Section 16 Planning Application for Proposed Minor Relaxation of the Maximum Domestic GFA for the Permitted Residential Development of the Urban Renewal Authority Sai Yee Street/ Flower Market Road Development Scheme (YTM-013) (Planning Application No. A/K3/603)

Responses to Departmental Comments Table

Drawing Title			
PROPOSED WIDENING OF SIGNALISED CROSSINGS			
Designed	HMC	Checked	CYH
Scale	1:500(A3)	Date	AUG 2026
Drawing No.	5.1	Rev.	A

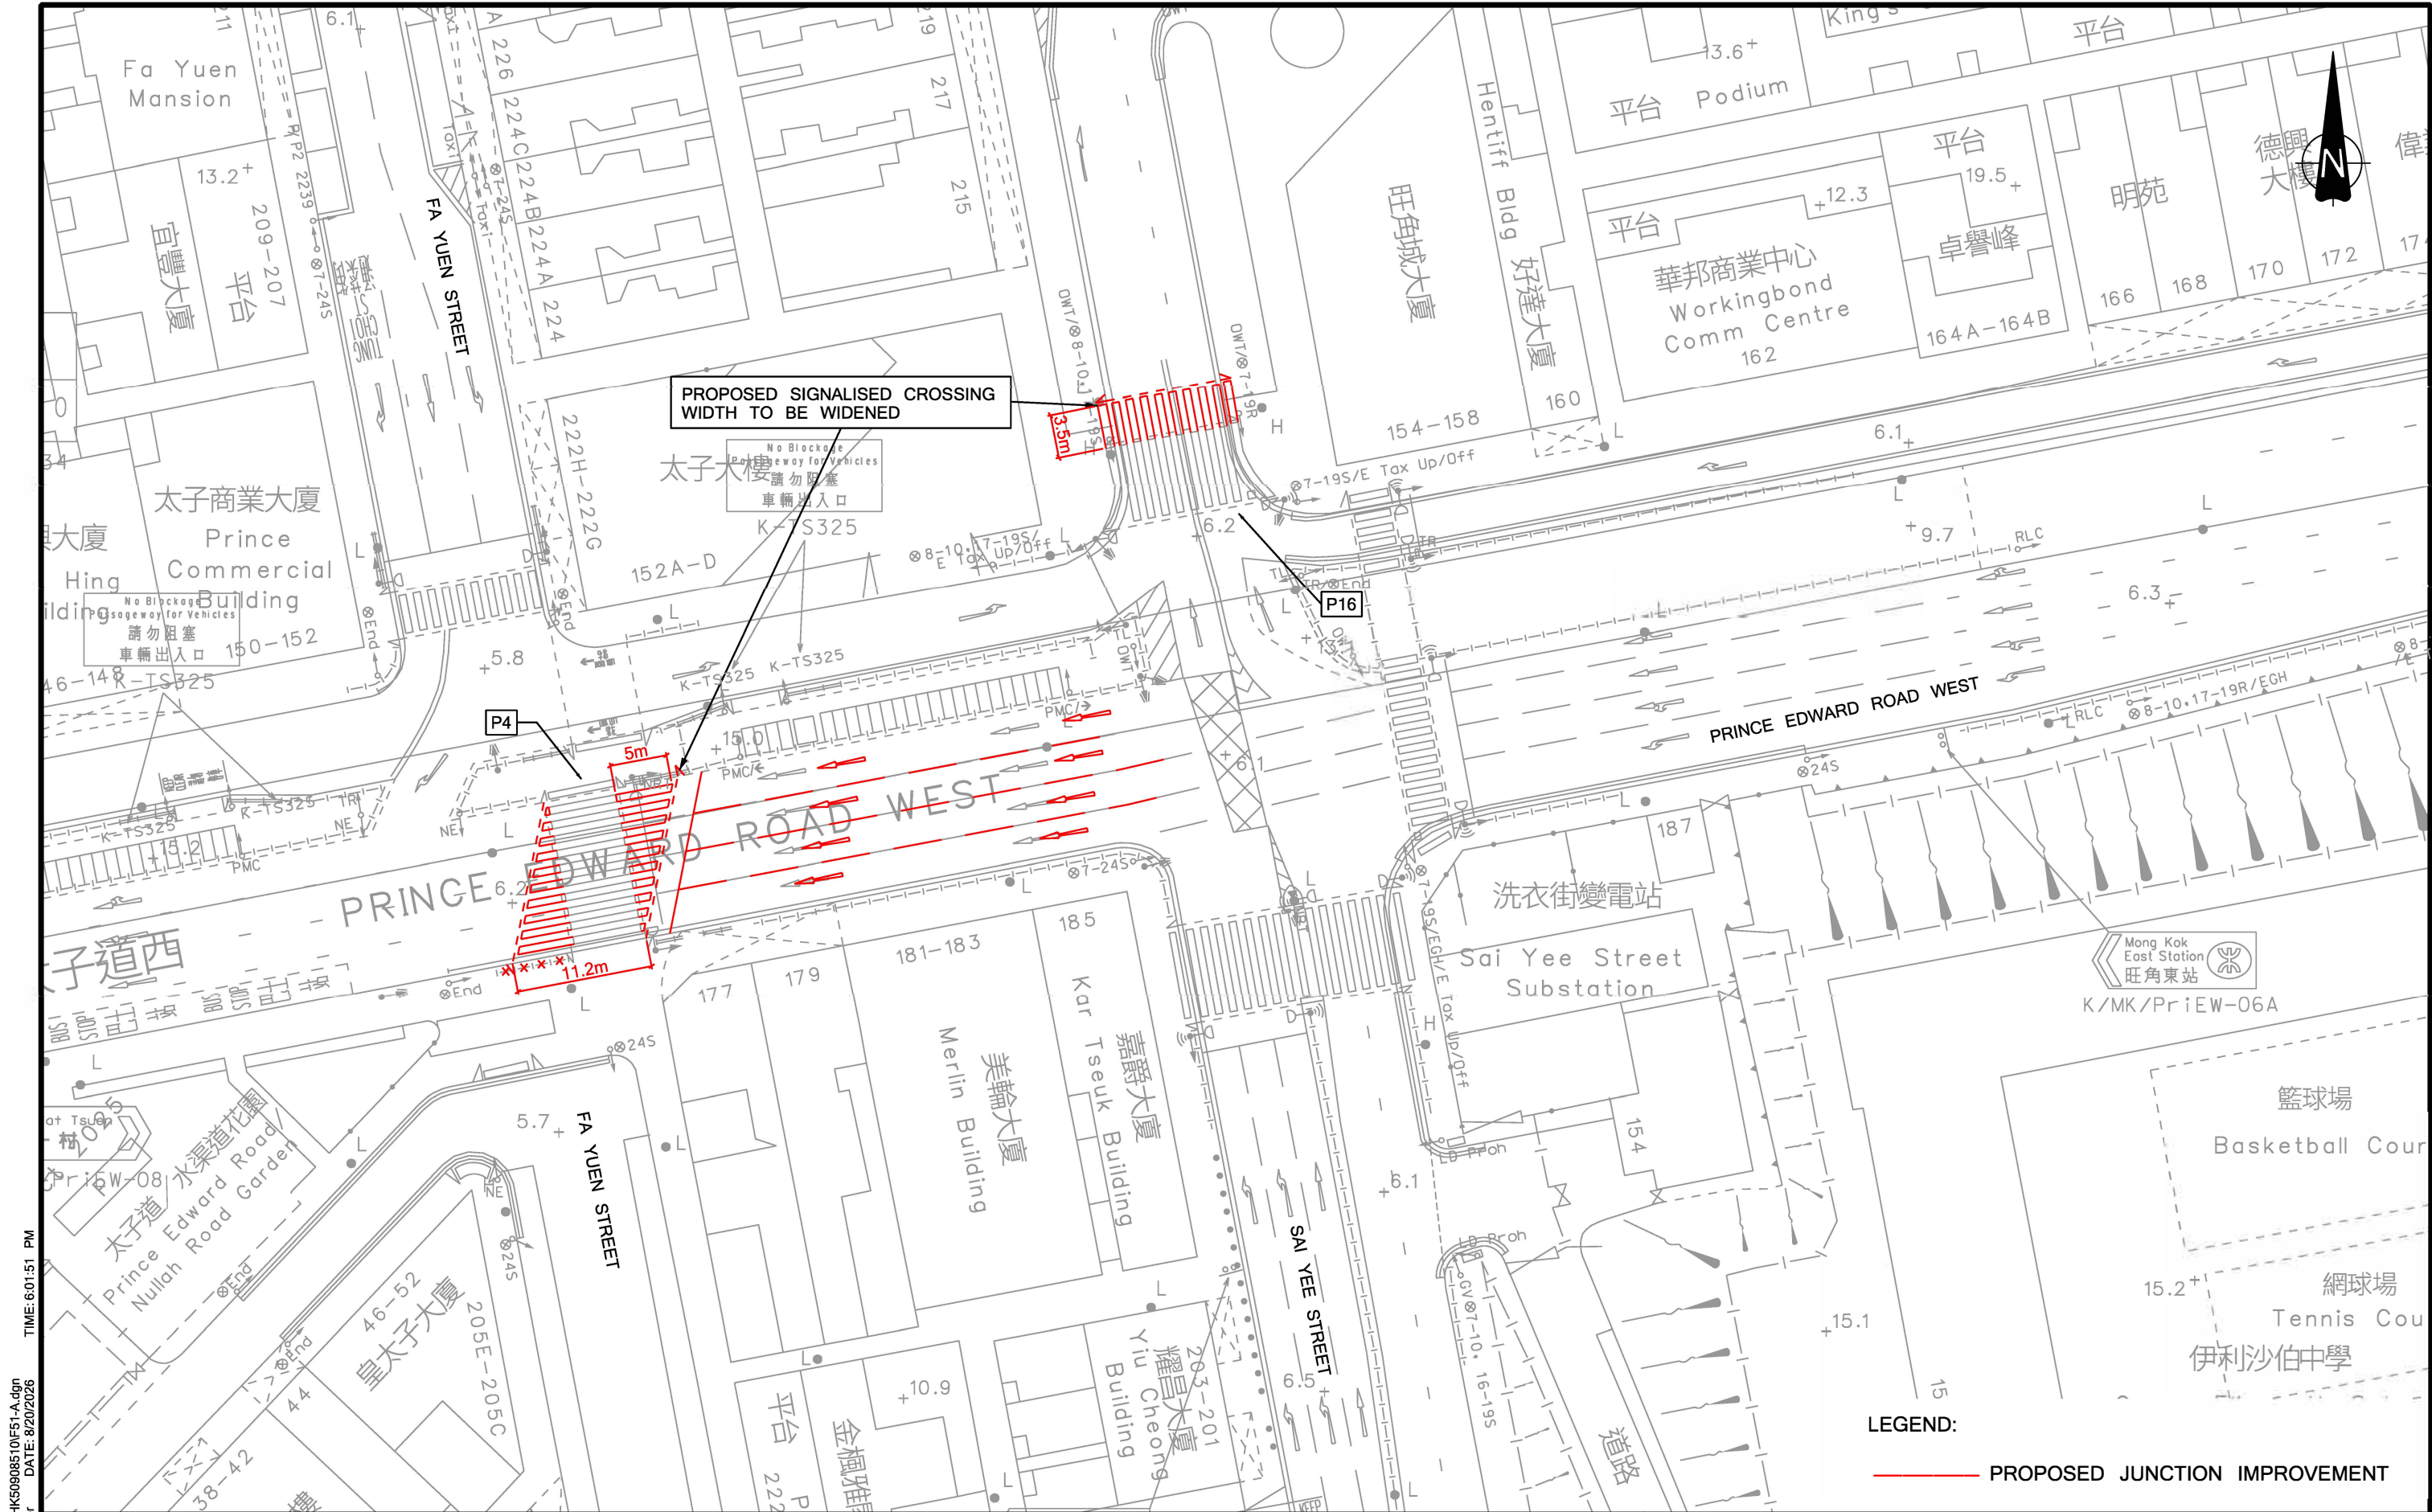
Departmental Comments	Responses
1. Comments from Commissioner of Police (CP)	
<i>Received via email dated 7 Aug 2026</i>	
Widening of Pedestrian Crossings (a) Chapter 5 of the Traffic Impact Assessment (TIA) indicates that the signalized crossings across Prince Edward Road West / Fa Yuen Street (P4) and Sai Yee Street near Prince Edward Road West (P16) are already overloaded during existing weekend peak hours. With the additional foot traffic generated by the proposed development, further congestion at these crossings is expected. Overcrowding at these key crossings will cause pedestrian queues to spill off the footpaths and onto active traffic lanes. This creates a severe risk of traffic accidents and will demand continuous and substantial police manpower deployment for crowd and traffic control. The proposed physical widening of signalized crossings (i.e. P4 and P16) should therefore be mandatory.	Noted. The two proposed signalized crossings were already proposed in the TIA at the DSP planning stage to address the local traffic conditions. It is not resulted from the current S.16 planning application. Upon implementation of the approved DSP, URA will implement the proposed physical widening of signalized crossings (P4 and P16), subject to technical feasibility and agreement with relevant Government departments. The detailed design, layout, implementation programme of the proposed widening will be further developed in the implementation stage in consultation with TD, HKPF and other relevant Government departments as appropriate.
